# A303 Amesbury to Berwick Down

TR010025

## Additional Submission AS 10 – Shared Use Cycle Route Clarification Note

### Shared Use Cycle Route Clarification Note

**Figure 3-1 – Abstracts from original and updated General Arrangement Drawings' Legend**

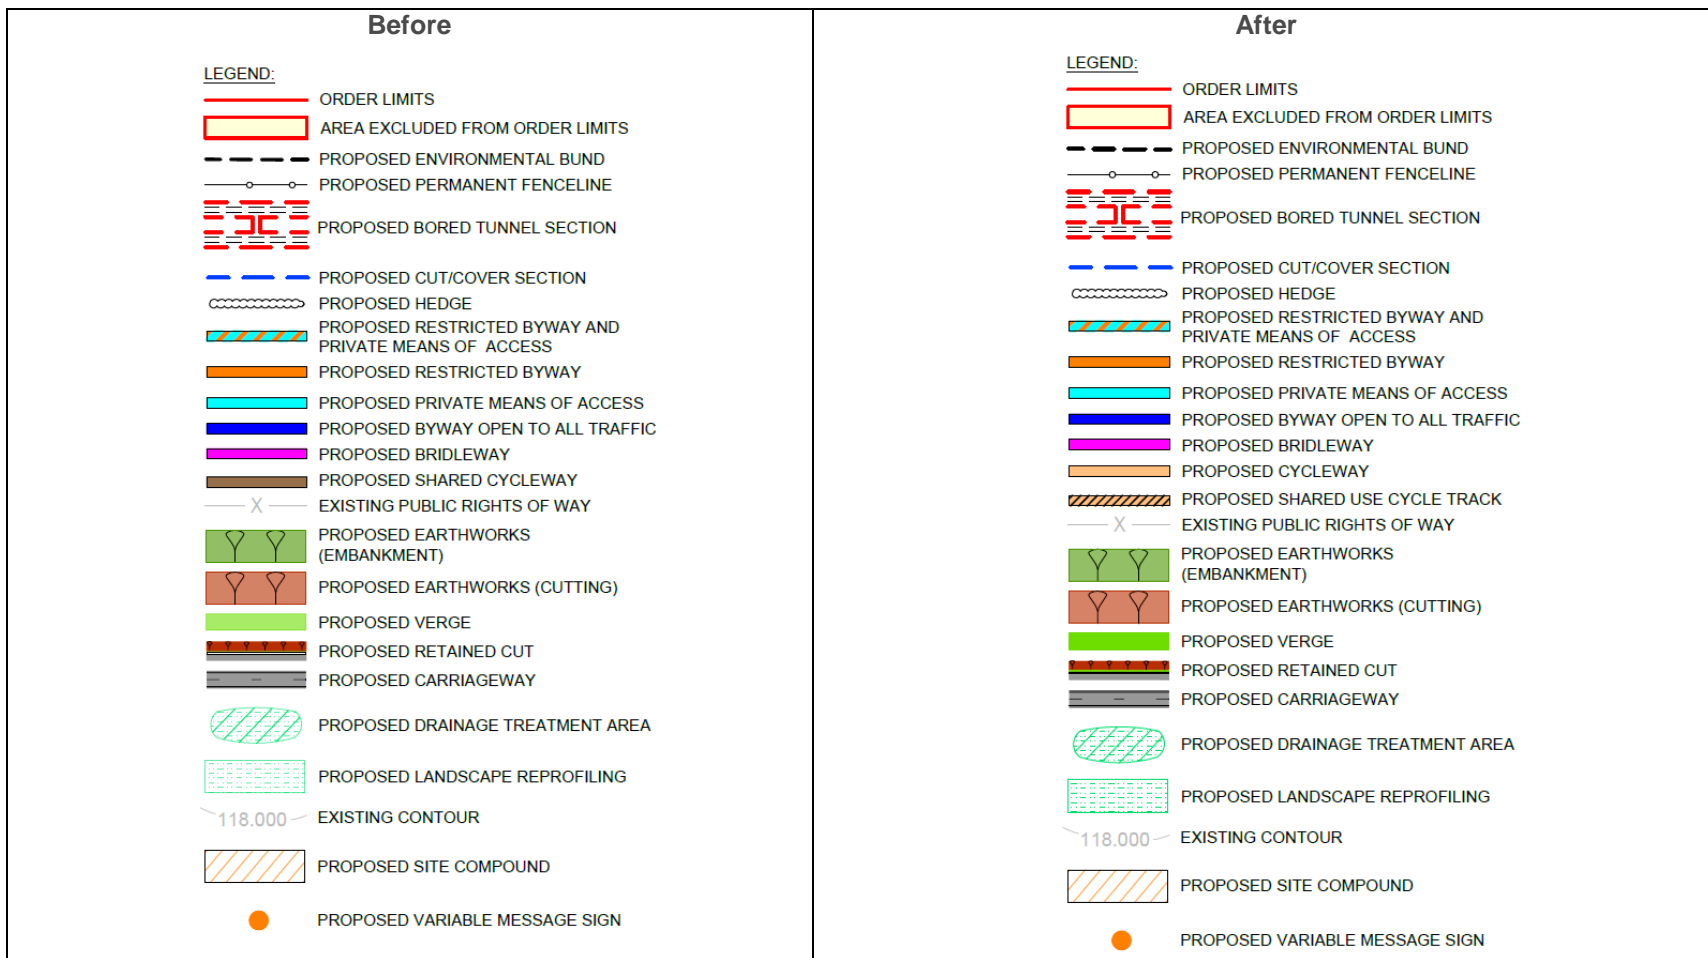
3.1.2 **Sheets 1 to 15** - The legend (or 'key') will be updated on the full set of General Arrangement Drawings. An abstract of the existing legend and the proposed updated legend are shown side by side in Figure 3-1 below. The brown route showing "proposed shared cycleway" is to be replaced by a pastel orange route with black diagonal lines overlaid to show "proposed shared use cycle track" and a pastel orange route to show "proposed cycleway", reflecting the terms used in the draft DCO.

Figure 3-2 – Abstracts from submitted and updated General Arrangement Drawings Sheet 3

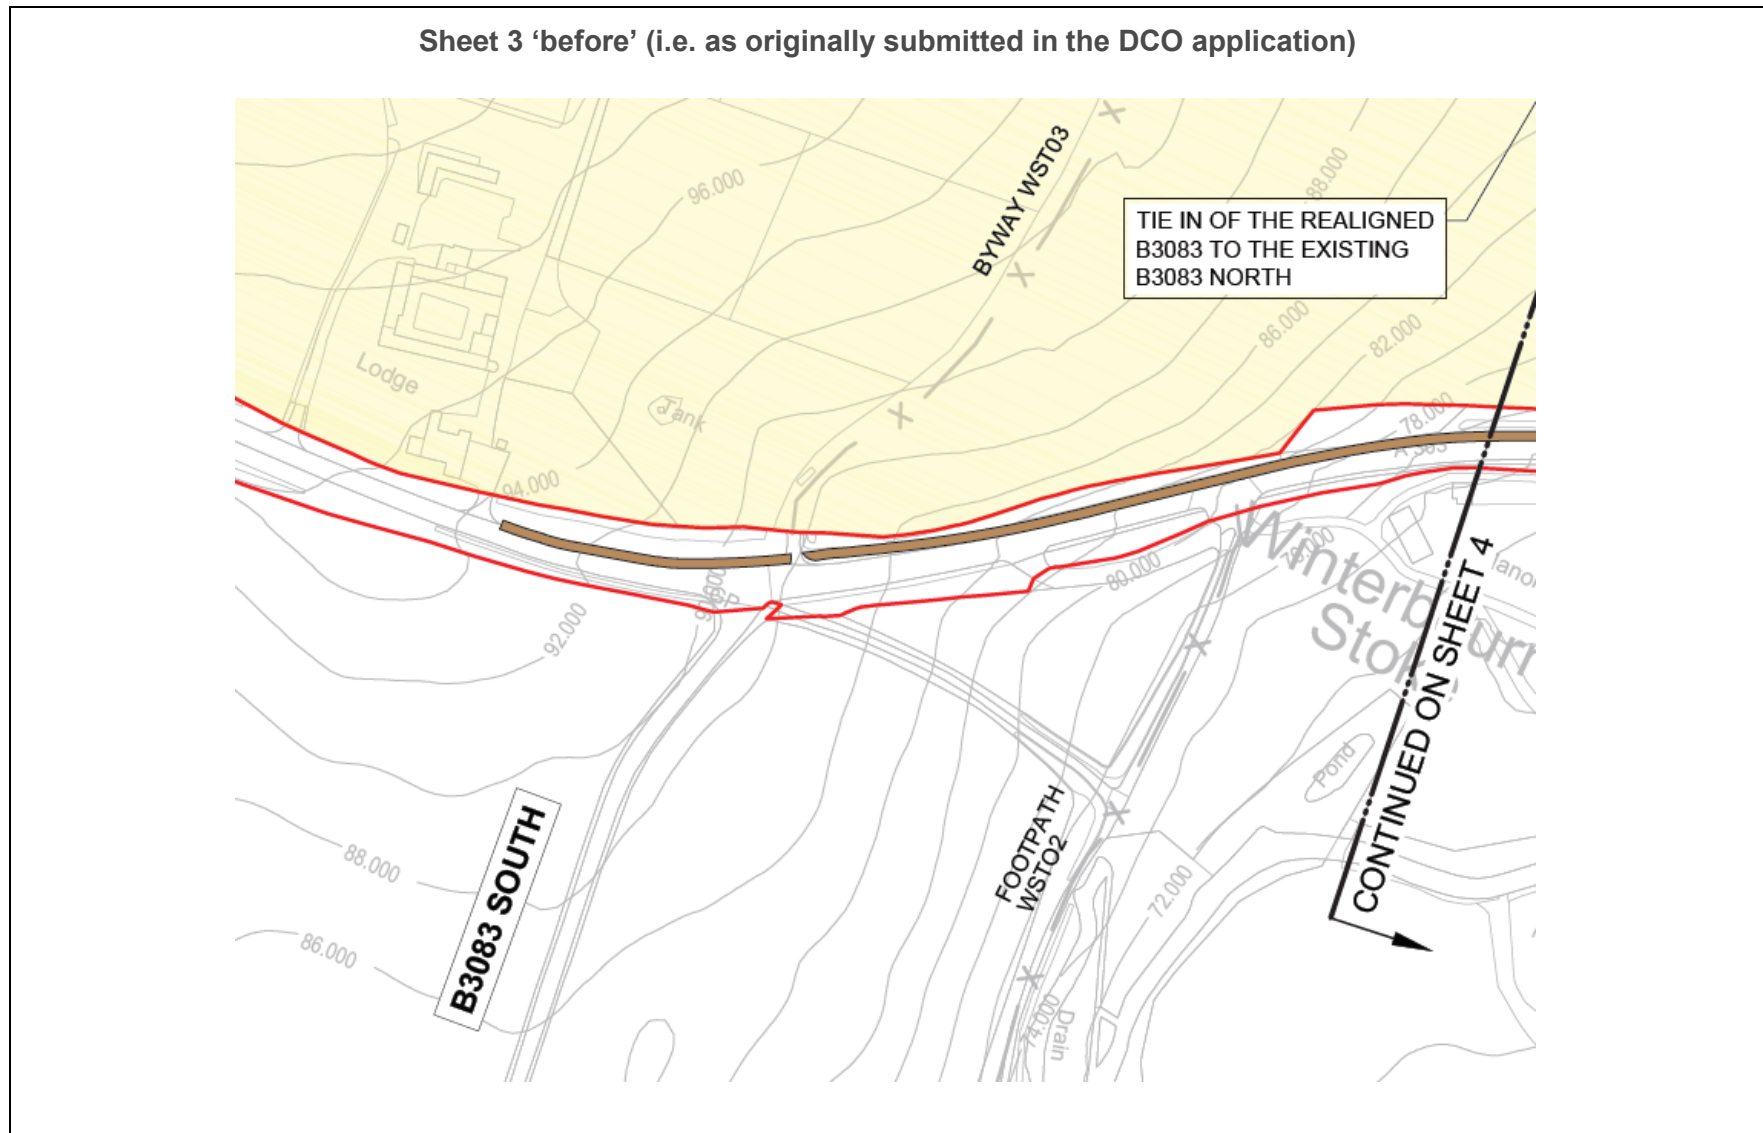
- 3.1.3 **Sheets 3 and 4** – the proposed brown route running along the northern verge and footway of the existing A303 between Scotland Lodge Farm and the western side of Winterbourne Stoke is intended for pedestrians and cyclists only and thus will be identified in the updated General Arrangement Drawings as a proposed shared use cycle track, shown in pastel orange with black diagonal lines overlaid. Equestrians would not be permitted on this shared use cycle track, but would be able to use the adjacent road through the village of Winterbourne Stoke, which, with the Scheme in place, will have much lower traffic flows following the removal of A303 through-traffic, and which will be subject to a 30mph speed limit.

- 3.1.4 Relevant abstracts of the existing General Arrangement Drawings Sheets 3 and 4 (marked ‘before’) and the proposed clarification (marked ‘after’) are shown in Figures 3-2 and 3-3 below.

**Figure 3-4 – Abstracts from submitted and updated General Arrangement Drawings Sheet 5**

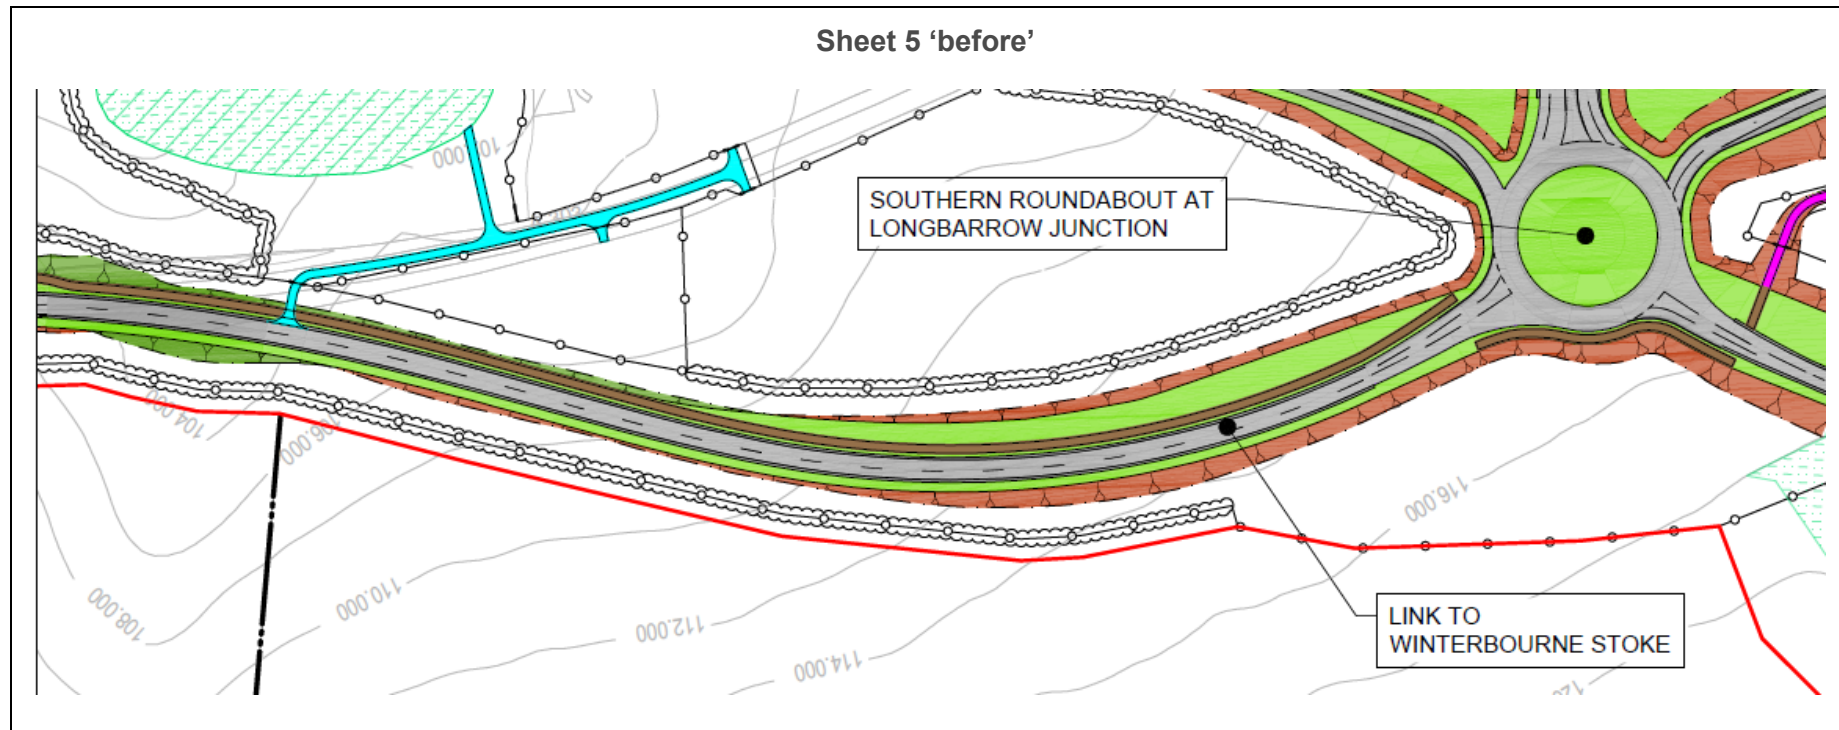
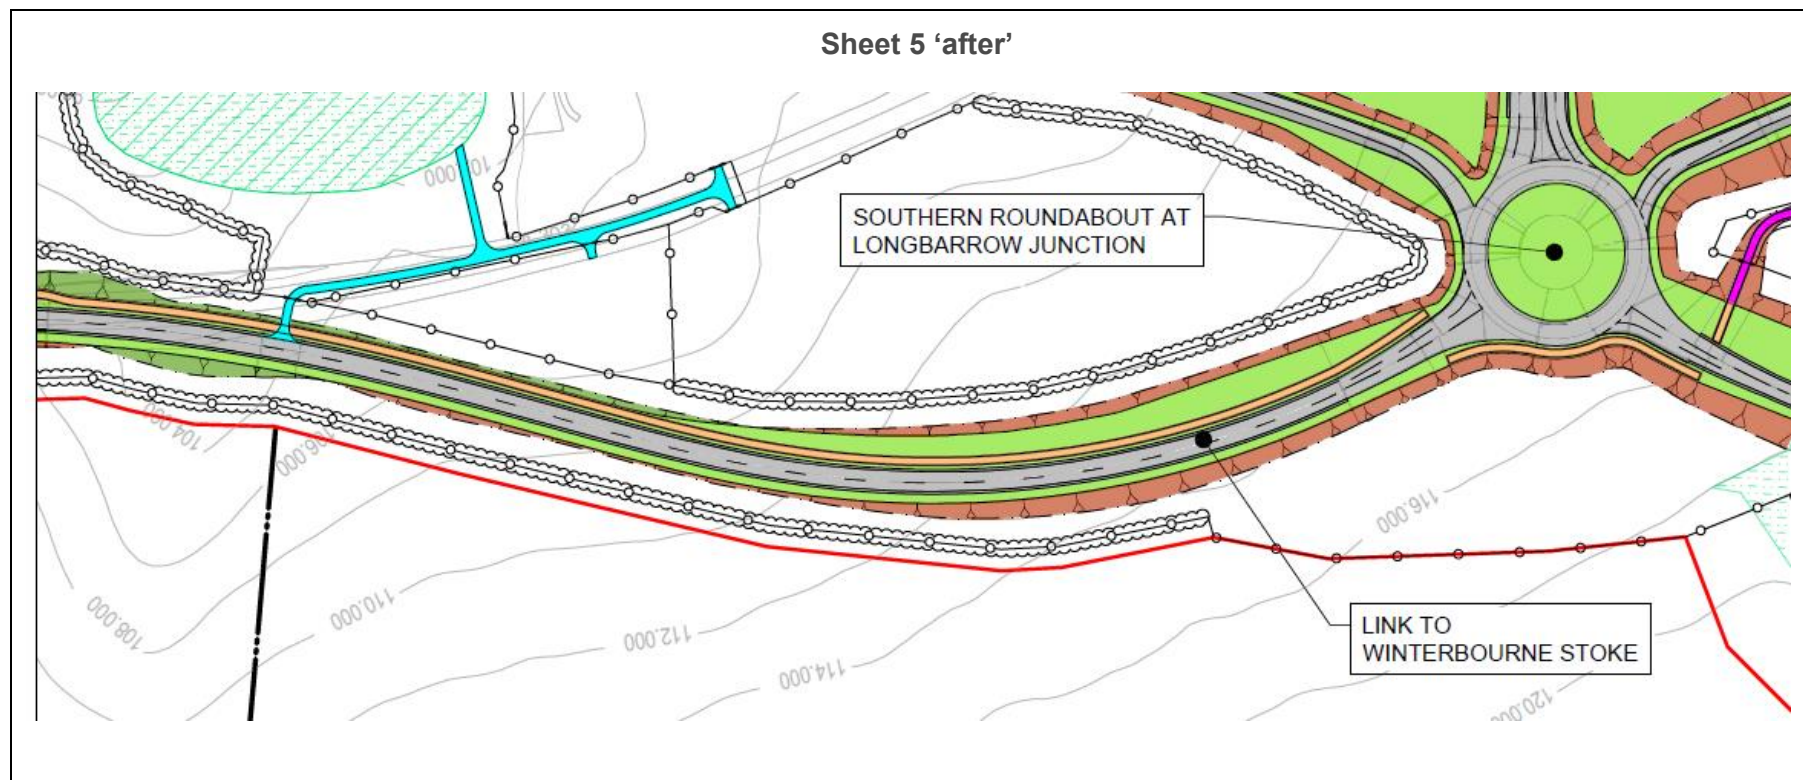
- 3.1.6 **Sheet 5** – the proposed brown route running along the northern side of the new link road (between the former A303 and the proposed Longbarrow southern roundabout, extending around the roundabout and leading into the proposed bridleway linking the new roundabout with the proposed restricted byway along the route of the existing A303) is intended for pedestrians, cyclists and equestrians only and thus will be identified as a “proposed cycleway” and shown in pastel orange on the updated General Arrangement Drawings.
- 3.1.7 Relevant abstracts of the existing General Arrangement Drawings Sheet 5 and the proposed clarification are shown in Figure 3-4 below.

Figure 3-5 – Abstracts from submitted and updated General Arrangement Drawings Sheet 14

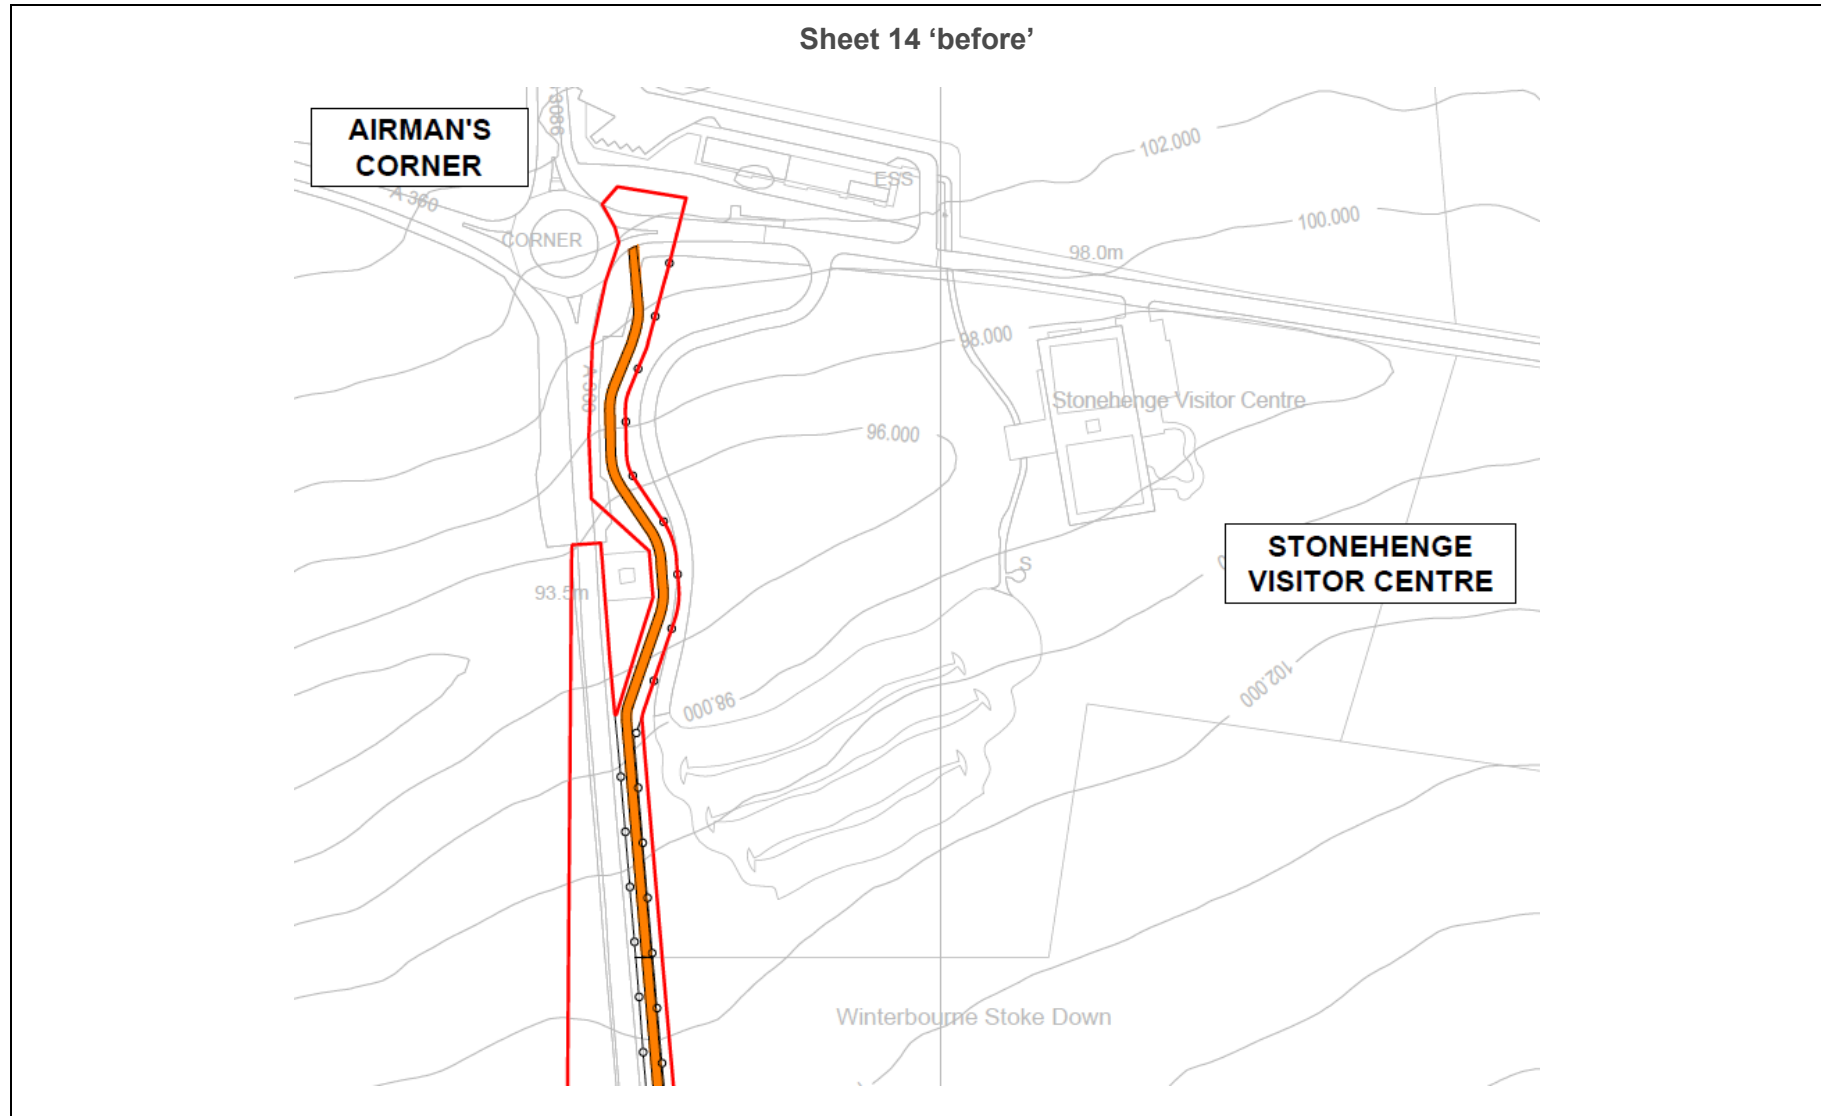
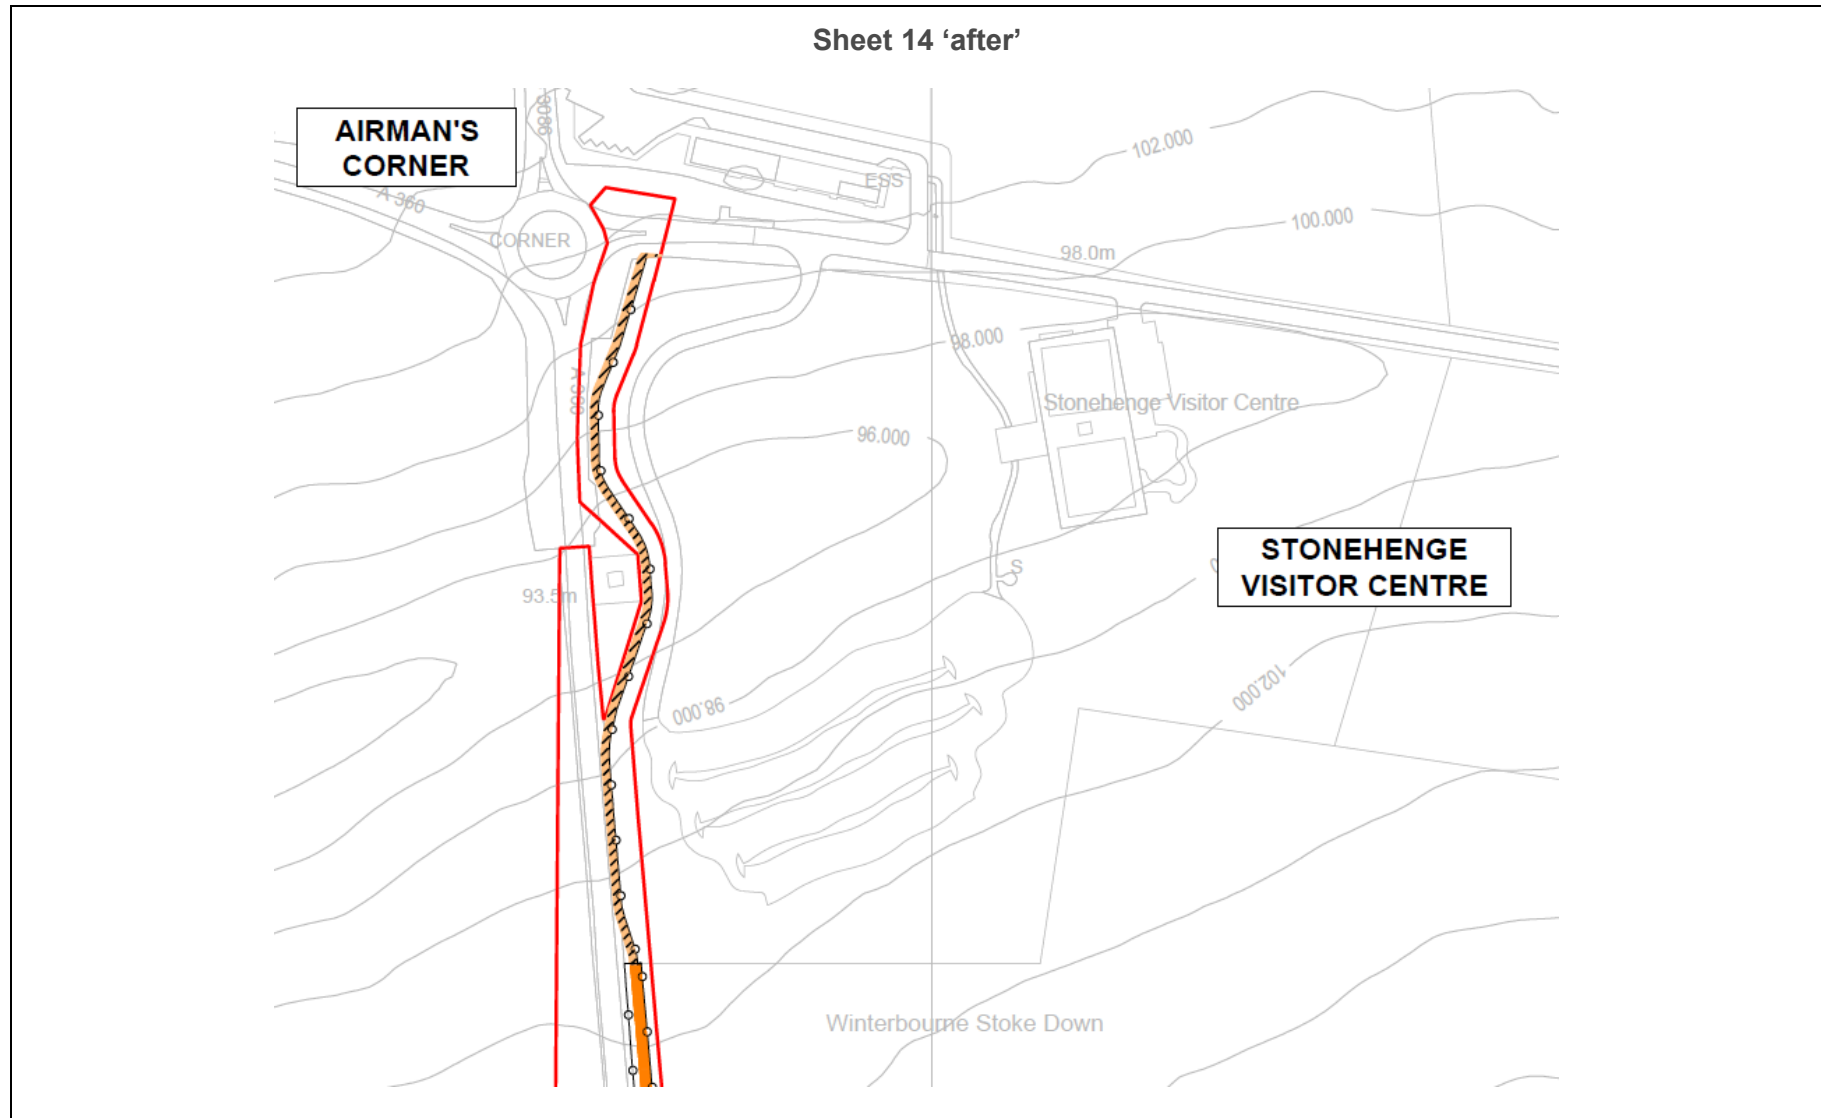
- 3.1.8 **Sheet 14** – Subject to the Examining Authority’s acceptance of proposed change NMC-06 Option B (or the related substitute solution), the proposed restricted byway along the east side of the A360 next to the Stonehenge Visitor Centre would be changed to a “shared use cycle track” intended for pedestrians and cyclists only and shown in pastel orange with black diagonal lines overlaid on the updated General Arrangement Drawings.
- 3.1.9 Relevant abstracts of the existing General Arrangement Drawings Sheet 14 and the proposed clarification are shown in Fig 3-5 below.
